14 October 2020

DUNMORE SAND AND SOIL MODIFICATION 2 RESPONSE TO QUERIES FROM PANEL 7 OCTOBER 2020

DUNMORE LAKES SAND EXTRACTION PROJECT | MODIFICATION 2
ENVIRONMENTAL ASSESSMENT

Figure 1
Extraction setbacks

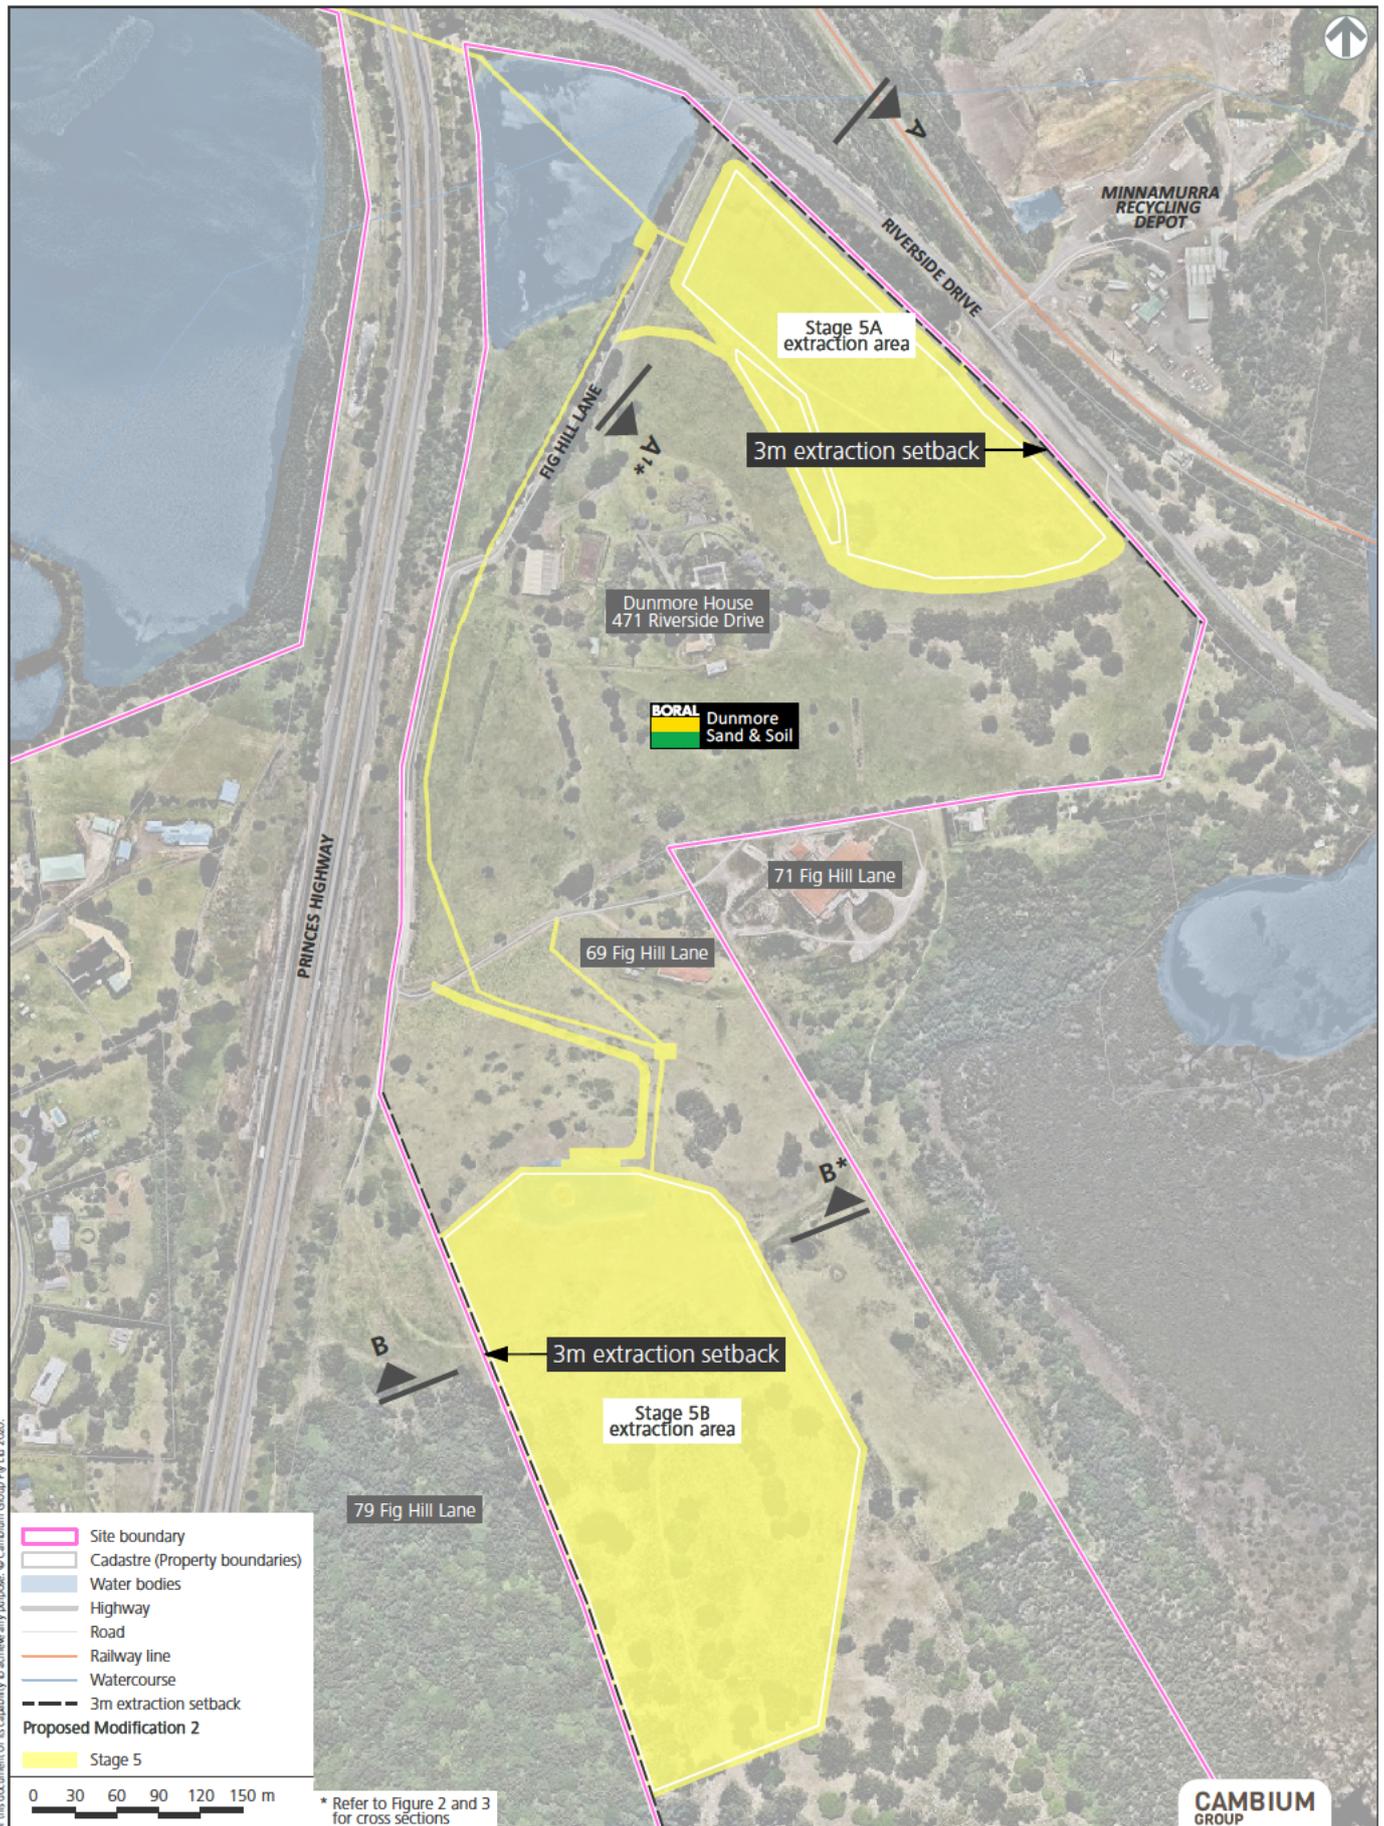
6. A setback diagram for Stage 5B pond showing the 3m standoff

See attached diagram included in Appendix B.

Figure 3
Stage 5B extraction area cross section

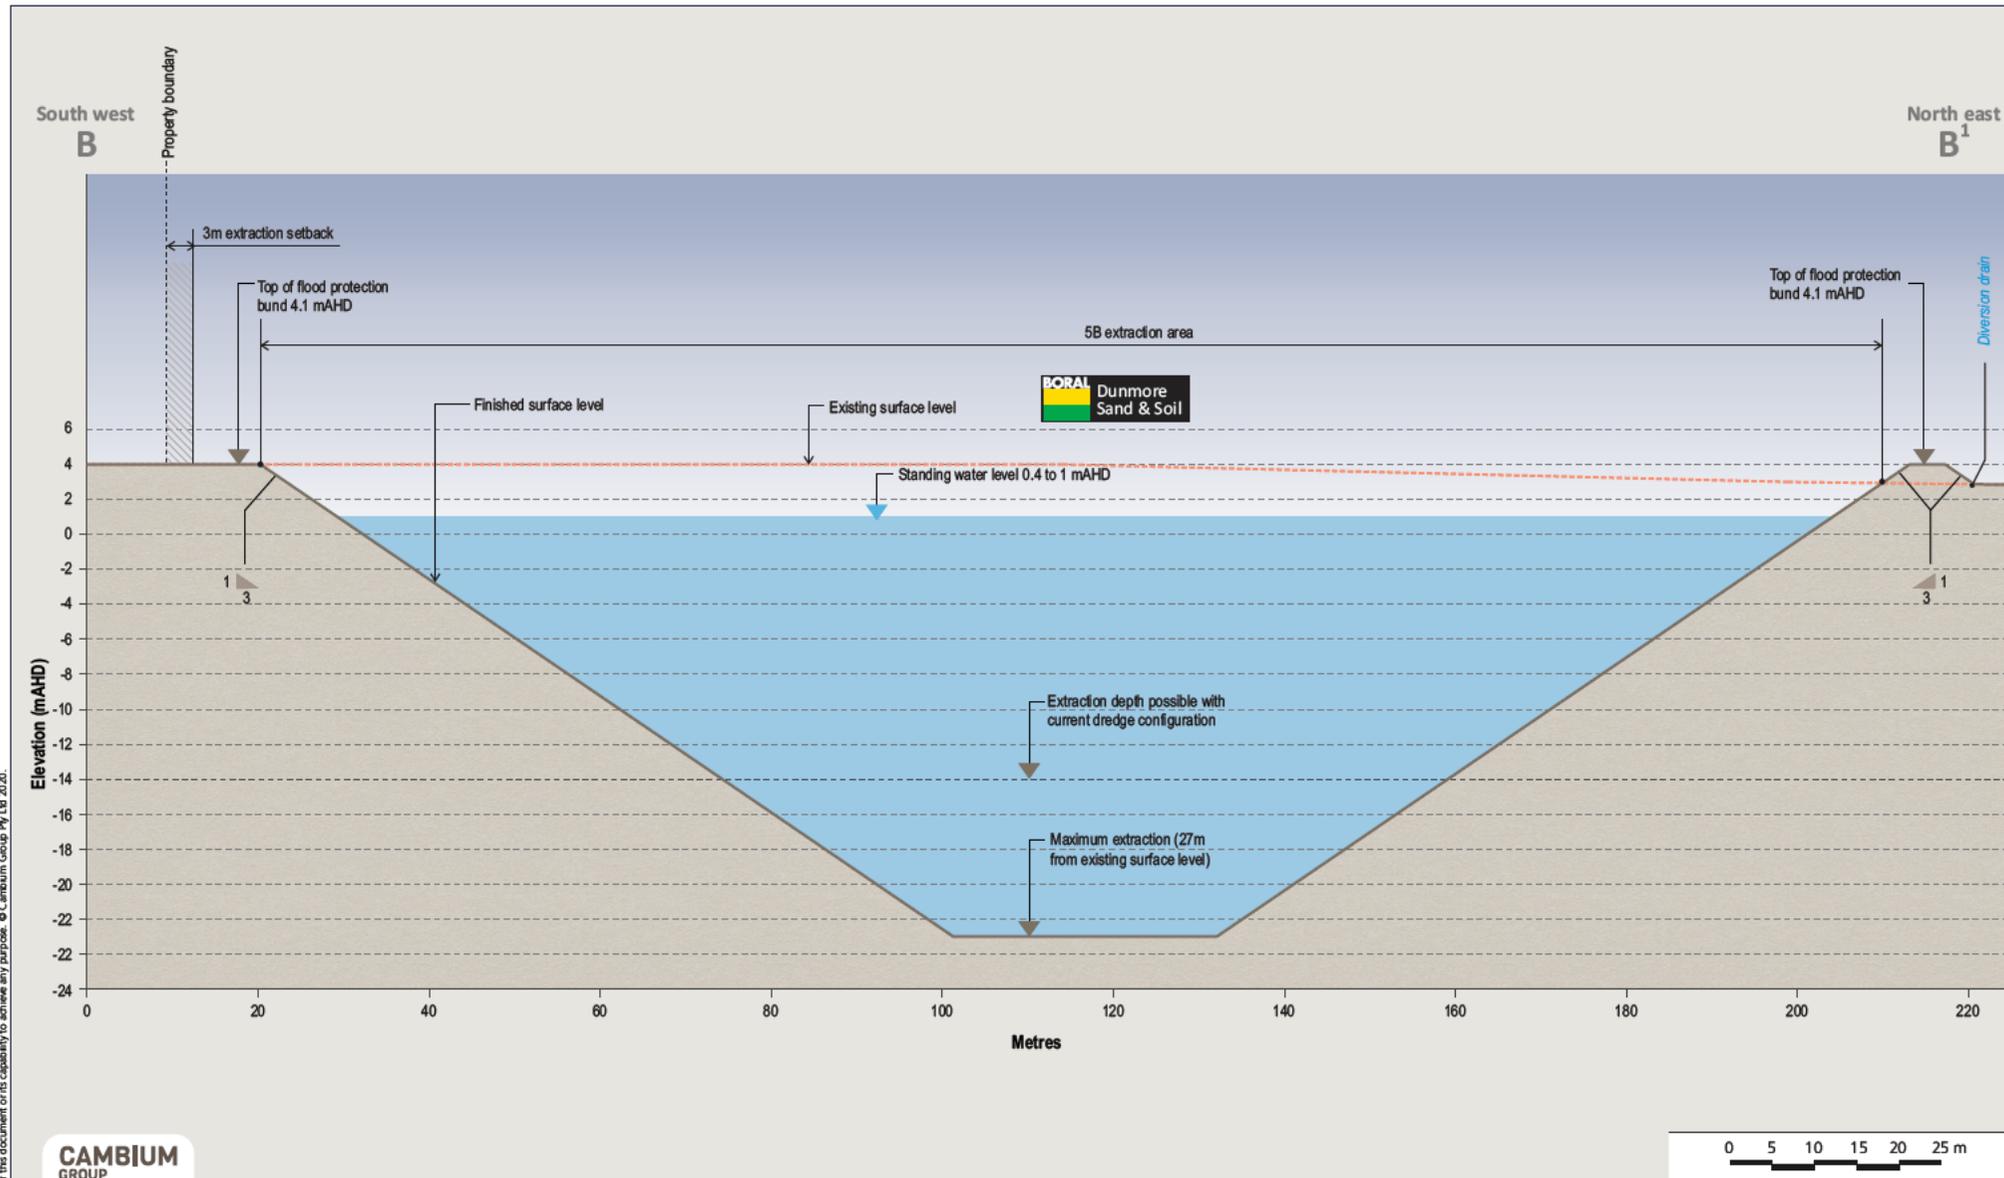
7. A cross-section of the Stage 5B pond illustrating the max depths (from pond edge to deepest point)

See attached cross sections included in Appendix C.
